Doors & Hardware

Drywall

Acoustical Ceiling

1		RFI 01	3/31/22
REV	APPROVED DATE	DESCRIPTION	JCN REDLINE DATE APVD
DEPARTMENT OF TRANSPORTATION FEDERAL AVIATION ADMINISTRATION ATO - TECHNICAL OPERATIONS WESTERN SERVICE AREA			
ARTCC RECONFIGURE M1 ROOM MAIN FLOOR PLAN			
PALMDALE		LOS ANGELES CTR CA	
REVIEWED BY	SUBMITTED BY	APPROVED BY	
	ART GAPASIN PROJECT ENGINEER	DARYL KITCHEN MGR. ENGINEERING - LA	
DESIGNED	KDL	ISSUED BY	DATE 02.04.2021 JCN 1004394
DRAWN	KDL	ENGINEERING SERVICES	DRAWING NO
CHECKED	SJP	ENROUTE/FSS	ZLA-D-ARTCC- A101

C8 MAIN FLOOR PLAN
 1/8" = 1'-0"
 0 4' 8' 16'

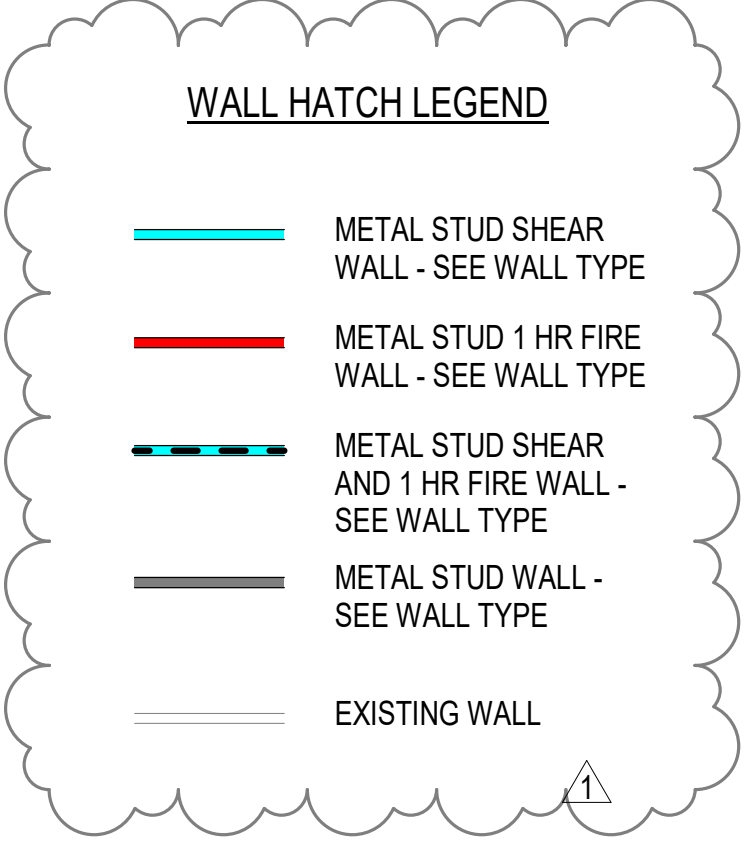
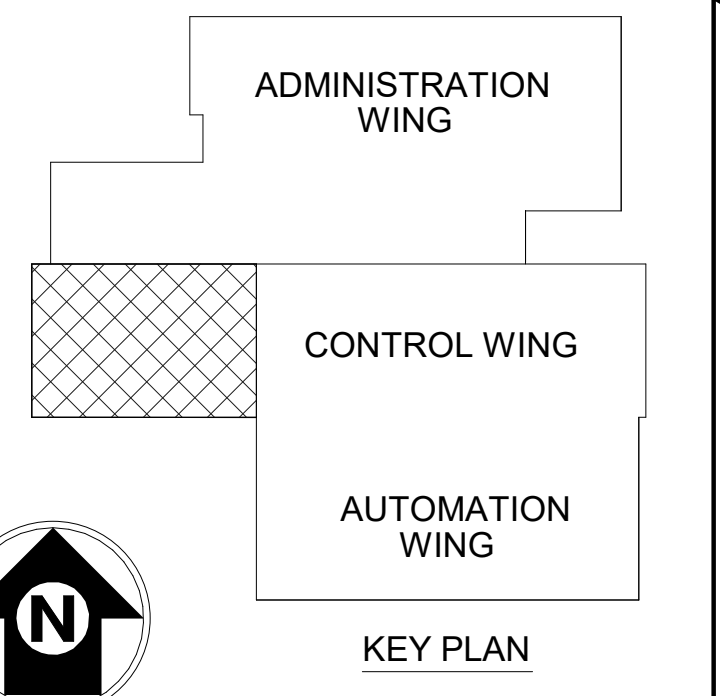
1. On sheet A1.1 I don't see wall types called out for the offices on the right side of the plan. Are these all type A? Break room walls show type B & D but the other two walls are not called out. **See attached revised A1.1.**

2. Some of the walls are colored RED and some Light BLUE. What is this to indicate?
See attached revised A1.1, wall hatch legend

C8 MAIN FLOOR FINISH PLAN
 1/8" = 1'-0"
 0 4' 8' 16'

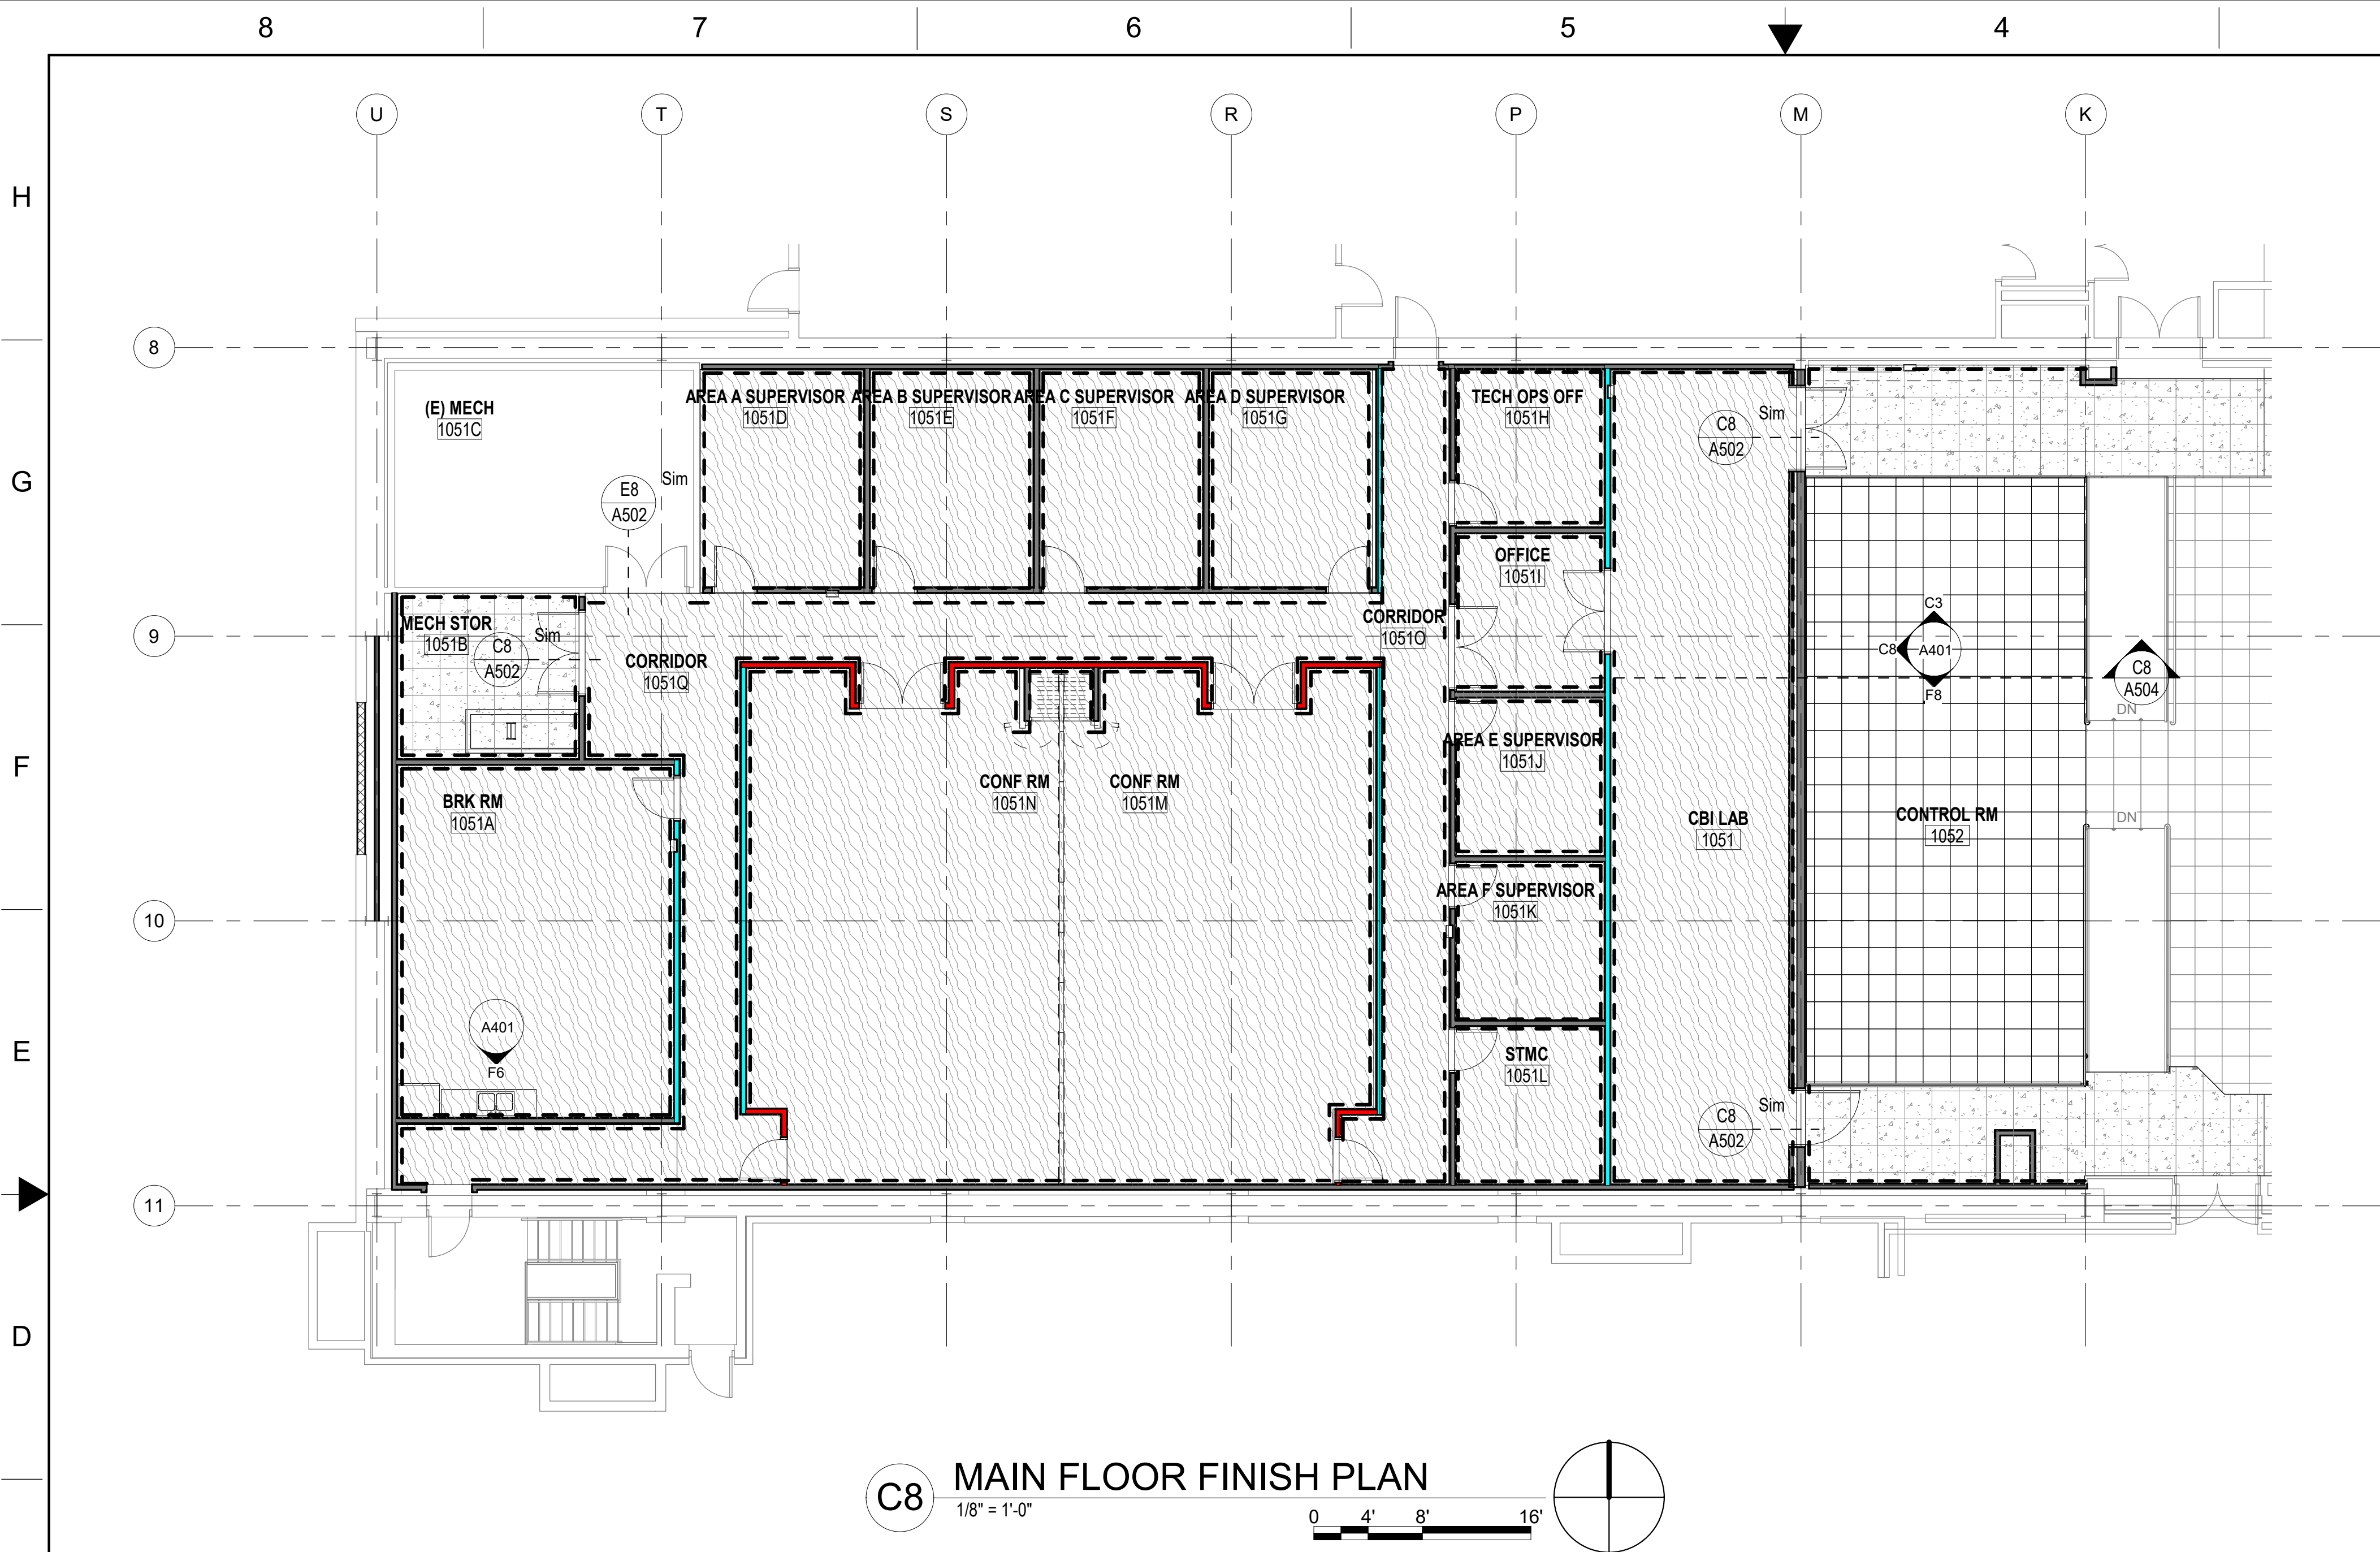
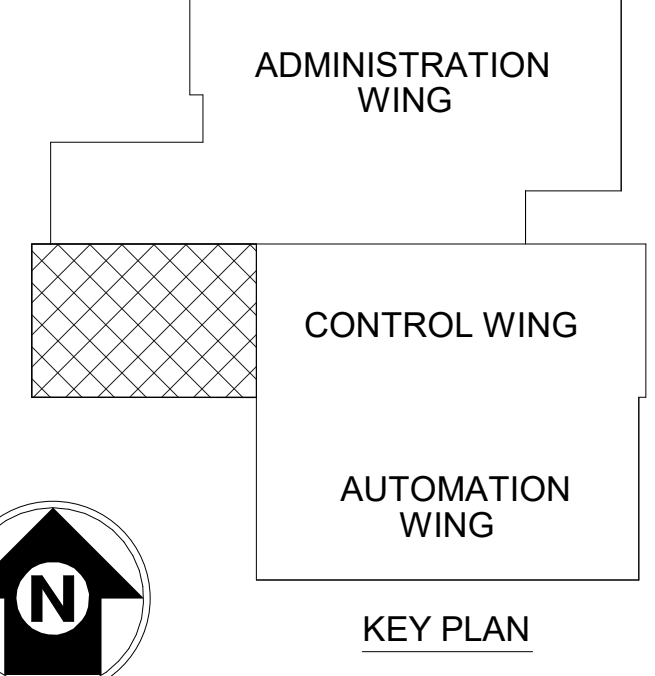
4. The Finish Schedule on Sheet A102 calls out for both CPT-1 and VCT-1 in the Control Rm, but we could only locate the location for the carpet tile. Please advise where the VCT-1 goes and confirm both it and the carpet tile will be field-applied by others.

Carpet is shown on raised flooring, and VCT is shown on the concrete floor to both sides. Carpet and VCT installation is means and methods?

5. The finish schedule calls for CPT0-1 in the mechanical storage room (1051B) but the floor plan shows Vinyl Composition Tile. Which is correct?

6. Control RM 1052 shows vinyl composition tile on each side of the access flooring. Is this flooring to be new? If so, where does it stop?

VCT is correct see revised A102

Yes on the flooring is new, we think grid K, unable to access this area. E-Corp researching .
